**Seattle  
Design  
Commission**

**MINUTES OF THE MEETING**

**January 17, 2008**

**17 January 2008 Project: West Thomas Street Pedestrian Overpass**

**Figure 1: Pedestrian overpass concept design.**

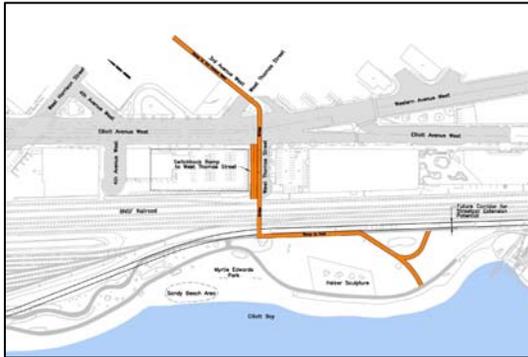
**The Commission thanks the team for their presentation, and while the Commission supports this project as a whole, it unanimously does not approve schematic design of the bridge alignment based on the following comments:**

- **Concern about moving forward into future design phases if this is the design due to current funding situations**
- **Concern over the level of detail presented, making it hard to review and feel it is lacking compared to past presentations. Contents shown a year ago offered more detail than presentation materials today.**

- **Concerns over crossing over Elliott, yet also understand the need to avoid a signalized crossing at Elliott.**
- **Concerns about future phases of the project without the accessible access point at Elliott**

- **Images of how the structure crosses Elliott are critical to understanding the project and the urban design merits, and must be displayed**
- **Suggest reconsideration of the phasing that includes phasing the Elliott crossing rather than the Elliott access point**

- **Great concerns about the safety for cyclists and pedestrians, especially at the corner intersections and 90 degree bend as the trail enters the park. Flaring, nodes, or other means of wider passage, including a belvedere or some means of respite, would add function, safety and good design**

- **Suggest the study of potential for simplifying the ramp alignment to the mound to avoid unnecessary kinks and cost in the project.**
- **The sloping mound as a starting point for the ramp is seen as a positive and unobtrusive element.**

- **The quality and application of utilitarian detail should achieve a higher standard than the images shown; learn from examples like the adjacent Sculpture Park.**
- **Utilize this as an opportunity to complement the Heizer Sculpture.**
- **If there is not going to be a multi-use trail, then regrade is recommended.**

- Walking through the images and plan, how does the overpass thread over the potential streetcar route and bike trail?
  - The bridge will extend about twenty feet beyond the trolley fence line and the ramp will be offset by the bridge centerline.

- It is hard to tell if the two girders dead-end in space, with a concrete slab beyond that.
  - Yes, they do.
- Is there a highway pass over the bridge? Will those be detailed similarly? Is there a single concrete pier?

- Can the team get rid of the ramp on Elliott and build stairs instead?
  - The team cannot pick and choose, due to ADA access.
- This is concept design, not schematic design. There are no sectional drawings or elevations. It is difficult to approve this project due to lack of documentation. SDOT should evaluate if they have adequate funding for the project. The same amount of detail from a year ago has not been presented today.

- Is there a baseline?
- Regarding the ramp east of Heizer, could the angle be more radial with a gently curved segmented precast?
  - That would be a cast in place solution, which would not be in the budget. Yes, the team will make it more round horizontally

- There are three aspects to the overpass, which include the part where it crosses Elliott that is visually significant, where it crosses the BNSF tracks that is less visually significant, and where it comes down to Myrtle Edwards Park. The path was created for bike ramps with the idea to cross Elliott and land gracefully in the park. However, pedestrians now cannot access a graceful arc across Elliott (steel with curve). Would value engineering permit access from the west side with steeper ramps?

- On a positive note, switch from steel to concrete is okay because it models the quality of the Heizer sculpture.
- There are visibility issues in turning corners over the I-90 trail due to limited sightline. A node for respite, clearances and corners need to be incorporated.

- Today's feedback can help gear the team towards design to improve the resolution of 90 degree turn and to resolve the blunt corner.
- What the DC suggested last year: west crossing, belvedere treatment, go directly south into the park

- The pier is 2.5 feet diagonally and will be round.
- Is there a stair tower at the corner?
  - There will be an open belvedere with a flare at the bridge.

- Yes, this ramp is at 5% but can increase to 8.3% which require landings that need to be 10 feet wide.
- Feel that the project is underfunded and worried about moving forward.
